Access Compliance Report

Public Rights-of-Way

Intersection ID: 44000	Main Street: ELROSE_PL	Cross Street: GANDER_DR	Location: SE
ADA ID: 76B00273707A	Ramp Type: BlendTrans1	Initial Pass/Fail: Fail	Overall Compliance: No
Severity Score: 12.5			
Codes/Mitigation Info/Possible Solution		Field Measurements/Component Compliance

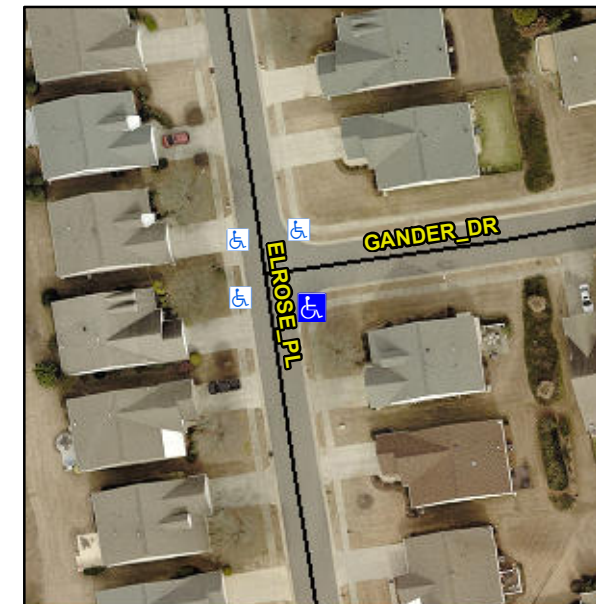
Not Found, R304.5.3

Compliance	Description	Data	Compliance	Description	Data
N/A	Ramp Length (in)	44.0	Yes	BlendTrans Slope (%)	1.1
Yes	Ramp Width (in)	69.0	No	BlendTrans XSlope (%)	6.5
N/A	Flare Type LT	N/A	N/A	Flare Type RT	N/A
N/A	Flare Slope LT (%)	N/A	N/A	Flare Slope RT (%)	N/A
N/A	Flare Traversable LT?	N/A	N/A	Flare Traversable RT?	N/A
N/A	Landing Length (in)	N/A	N/A	DWS Provided?	N/A
N/A	Landing Width (in)	N/A	N/A	DWS Contrast?	N/A
N/A	Landing Slope (%)	N/A	N/A	DWS Length (in)	N/A
N/A	Landing X Slope (%)	N/A	N/A	DWS Full Width?	N/A
N/A	Landing Curb? (Y/N)	N/A	N/A	DWS Offset (in)	N/A
N/A	Shared Landing?	N/A			
N/A	Gutter Ponding?	N/A	N/A	Gutter Slope (%)	N/A
N/A	Gutter Lip Ht (in)	N/A	N/A	Gutter X Slope (%)	N/A
N/A	Painted X Walk1?	No	N/A	Painted X Walk2?	No
	X Walk 1 Direction	To NW		X Walk 2 Direction	To W
	X Walk 1 Width (in)	N/A		X Walk 2 Width (in)	N/A
	X Walk 1 Slope (%)	0.4		X Walk 2 Slope (%)	4.4
	X Walk 1 X Slope (%)	5.3		X Walk 2 X Slope (%)	0.5

N/A	Ramp inside XWalk1?	N/A	N/A	Ramp inside XWalk2?	N/A
	Road Slope (%)	5.8		Clear Space?	N/A
	Road X Slope (%)	1.2	N/A	Clear Space to XWalk (in)	N/A
N/A	Any Obstructions?	N/A	N/A	Storm Grate/Utility Hazard?	N/A
	Obstruction Type			Storm Grate/Utility Type	
		N/A			N/A
			Yes	Surface Condition? (G/P)	Good
			No	Curb Slope (%)	27.7

Remove & Replace Curb Ramp With Two New Directional Ramps or Equivalent.
